CHANGE NOTIFICATION

Dear Sir/Madam: PCN#061715

Subject: Notification of Change of Crystals on the LTP5900/LTP5901/LTP5902

Failure Analysis Report

Failure Mode(s) at ECS:

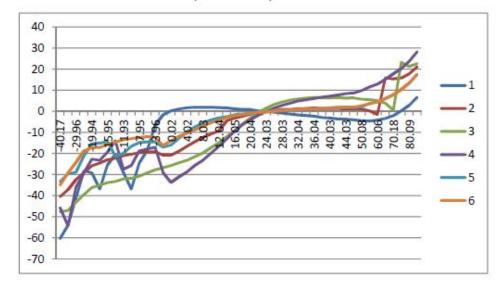
Units were found to be out of spec over temperature

The temp. stability failure is due to blank angle, We checked blank supplier and asked them to trace and check about the blanks they supplied

The root cause of this temperature characteristic problem is because of the blank's angle spread is getting bigger and has poor concentration which is related with the raw material's angle and smoothness as show in temperature data above.

We are moving forward with precision blank s for this item (New blank with ECD<100 and Q value = over 2.4 mil.), we asked blank manufacturer to build up with good quality quartz wafer and better as we already decided to use new blank s for this item

| Measuring extreme val | ue of nine points' thicknes | ss: | | | | | |
|--|-----------------------------|---|--|--|--|--|--|
| We will control the blank angle more tightly | | | | | | | |
| Blank Angle for CDX-0914 Rev. B = 3°01'00"±30" | | | | | | | |
| Before input the blank, will input testing lot for temp curve and will check if the blank angle is proper and all within the spec first for every lot. (as of 6/04/15) | | | | | | | |
